U.S. Appln. No. ◇
Page 3

Amendment to the Drawings:

REMARKS/ARGUMENTS

GP-302404
 Legal Staff, GM Corp., Detroit, MI
ANNOTATED SHEET
 2/3

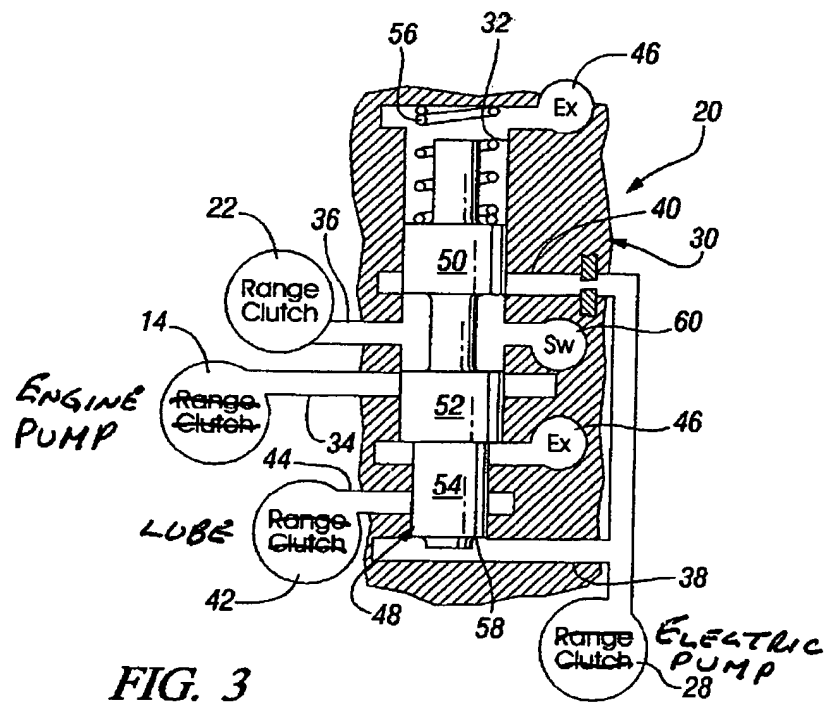
The attached sheet of drawings includes changes to FIGS. 2-5. Sheet 2/3, which includes FIGS. 2 and 3, replaces the original sheet 2/3 including FIGS. 2 and 3, Sheet 3/3 which includes FIGS. 4 and 5, replaces the original sheet 3/3 including FIGS. 4 and 5. In FIGS. 4-4, previously misnamed elements 14, 28, and 42 have been renamed to agree with the Specification.
